## City of Mississauga Department Comments

File(s): A533.21 Ward: 1

Property Address: 711 Third Street

The application proposes to permit a landscape trailer requiring variances related to trailer length and height.

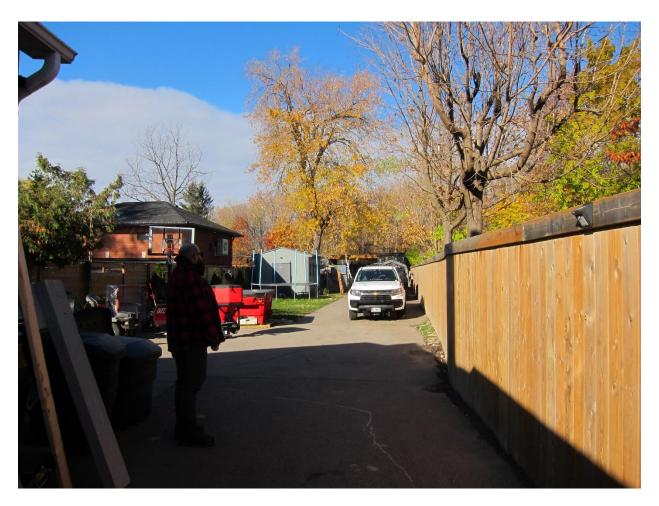
The drawings provided do not indicate any screening measures that exist or will be added to mitigate any potential massing impacts caused by the trailer. Zoning staff has also indicated that the applicant will require additional relief from the zoning by-law to permit the trailer on the subject property. Furthermore, staff attended a site visit and determined that additional variances may be required to accommodate existing accessory structures (shipping containers, sheds, structures etc.) and a widened driveway.

This Department has reviewed the subject application and advise that we have no concern with the parking of the trailer on the subject property. However, we draw attention to the attached pictures of the existing property. We do note that it appears that there are a number of other trailers parked on site and a number of accessory structures, tents and cargo containers that also appear to require minor variance relief. Although there are currently no drainage complaints for this property, we note that a significant portion of the rear yard is paved asphalt hard surface.

As such, staff recommend the application be deferred to give the applicant an opportunity to review the proposal with zoning staff, to verify the requested variances and identify any additional variances that may be required.
